TECHNICAL BULLETIN #58

SUBJECT: Aqualung regulator service kit information cards with incorrect o-ring part numbers

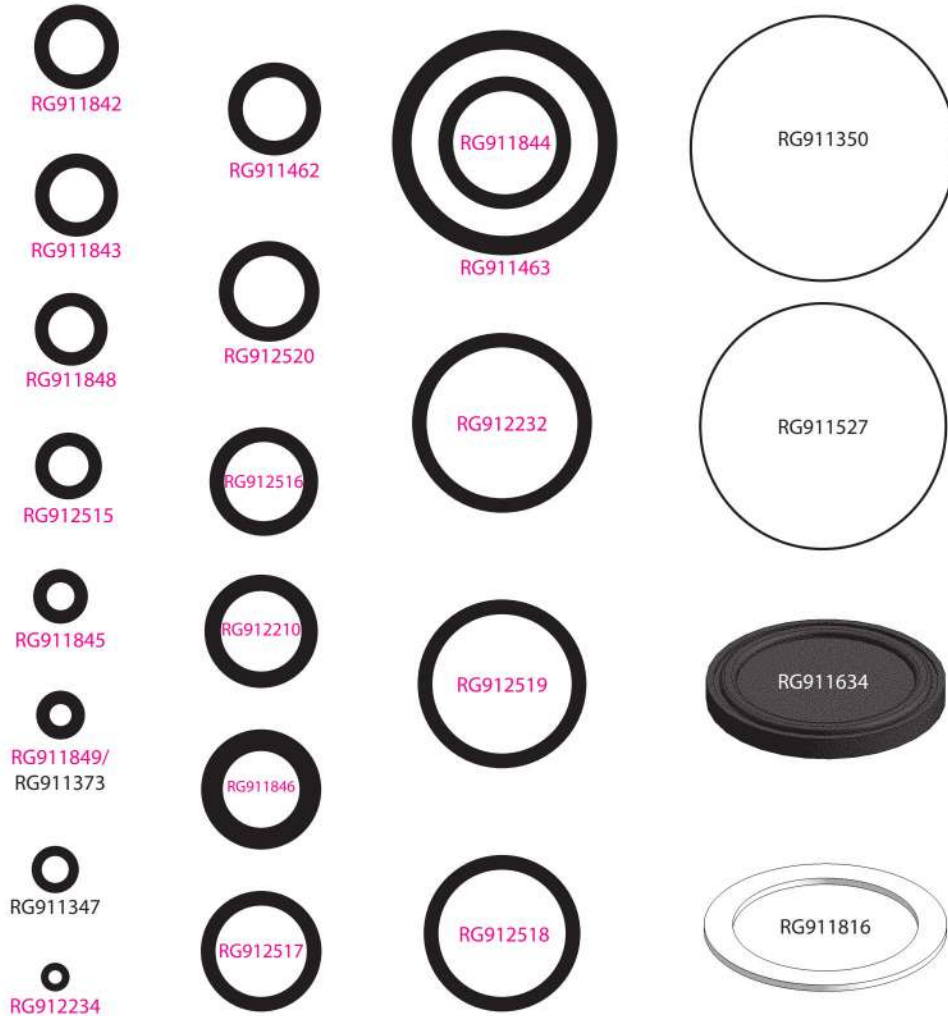
The service kit information card in our current revision of regulator service kits have o-ring part numbers on the card that are incorrect and do not match the part numbers on the schematics in the Spare Parts Guide or the Technical Maintenance Manuals. We are in the process of getting new cards which will be used in the next round of service kits manufactured. To assist you with servicing your regulators, we are providing a copy of the revised card with the correct o-ring part numbers shown in red. This card's part numbers match the numbers in the schematics. The pictures of the o-rings have not been affected by this and are the correct size.

RA121124	Service kit piston 1 st stage	Calypso	
		<2010	≥2010
RG911324	HP seat	1	1
RG911462	O-ring	1	1
RG911842	O-ring	4	4
RG911845	O-ring	2	1
RG911463	O-ring	1	1
RG911846	O-ring	DIN	DIN
RG911650	Filter non-ACD	1	1
RG911844	O-ring	1

RA121125	Service kit 1 st stage balanced diaphragm	Titan ≥ 2010/Mikron < 2017		Titan LX ≥ 2010				Core/Mikron ACD	
		STD	SUP	Non ACD		ACD		STD	SUP
				STD	SUP	STD	SUP		
RG911444	HP seat	1	1	1	1	1	1	1	1
RG911843	O-ring	1	1	1	1	1	1	1	1
RG911527	Diaphragm secondary		1		1		1		1
RG911848	O-ring					DIN	DIN	DIN	DIN
RG912520	O-ring					DIN	DIN	DIN	DIN
RG911846	O-ring	DIN	DIN	DIN	DIN	DIN	DIN	DIN	DIN
RG911676	Filter ACD					1	1	1	1
RG912515	O-ring					YOKE	YOKE	YOKE	YOKE
RG911350	Diaphragm	1	1	1	1	1	1	1	1
RG911347	Backup ring	1	1	1	1	1	1	1	1
RG911523	Washer	1	1	1	1	1	1	1	1
RG911849	O-ring	1	1	1	1	1	1	1	1
RG912210	O-ring	1	1	1	1	1	1	1	1
RG911462	O-ring	2	2	2	2	2	2	2	2
RG911842	O-ring	4	4	4	4	5 YOKE / 4 DIN		5 YOKE / 4 DIN	
RG911650	Filter non ACD	1	1	1	1

RA121126	Service kit 1 st stage over balanced diaphragm	Legend			Glacia/Leg3nd	
		Non ACD < 2006	ACD		<2014	≥2014
			<2012	≥2012		
RG911444	HP seat	1	1	1	1	1
RG911843	O-ring	1	1	1	1	1
RG911347	Backup ring	1	1	1	1	1
RG911849	O-ring	1	1	1	1	1
RG911462	O-ring	2	2	2	2	2
RG911842	O-ring	5	5 YOKE / 4 DIN		5 YOKE / 4 DIN	
RG911846	O-ring	DIN	DIN	DIN	DIN	DIN
RG911650	Filter non-ACD	1				
RG911350	Diaphragm	1	1	1	1	1
RG911816	Thrustwasher	1	1		1	
RG912210	O-ring	1	1	1	1	1
RG911634	Diaphragm secondary	1	1	1	1	1
RG911676	Filter ACD		1	1	1	1
RG911848	O-ring		DIN	DIN	DIN	DIN
RG912520	O-ring		DIN	DIN	DIN	DIN
RG912515	O-ring		YOKE	YOKE	YOKE	YOKE

RA121127	Service kit 2 nd stage non-balanced	Calypso / Titan	
		Classic	QC
RG911842	O-ring	1	1
RG912518	O-ring		2
RG911848	O-ring	2	2
RG911782	Locknut	1	1
RG911333	MP seat	1	1
RG911844	O-ring	2	
RG912207	Poppet Bearing	1

RA121128	Service kit 2 nd stage balanced	Mikron	Titan LX	Core	Legend/Leg3nd			Glacia/Leg3nd Elite		
					NON LX/Leg3nd/ OCTOPUS	LX/LUX/Leg3nd MBS		OCTO-PUS	< 2012	≥ 2012
						< 2012	≥ 2012			
RG912515	O-ring					1				1
RG912198	MP seat	1	1	1	1	1	1	1	1	1
RG911848	O-ring	2	2	2	2	2	2	2	2	2
RG912232	O-ring		1	1	1	1	1	1	1	1
RG911844	O-ring	1	2	2	2	2	1	2	2	2
RG912234	O-ring	1	1	1	1	1	1	1	1	1
RG911842	O-ring	1	2	2	2	2	1	2	2	2
RG912516	O-ring	1								
RG912519	O-ring	1								
RG911845	O-ring	1								
RG911373	O-ring						1			
RG912517	O-ring						1
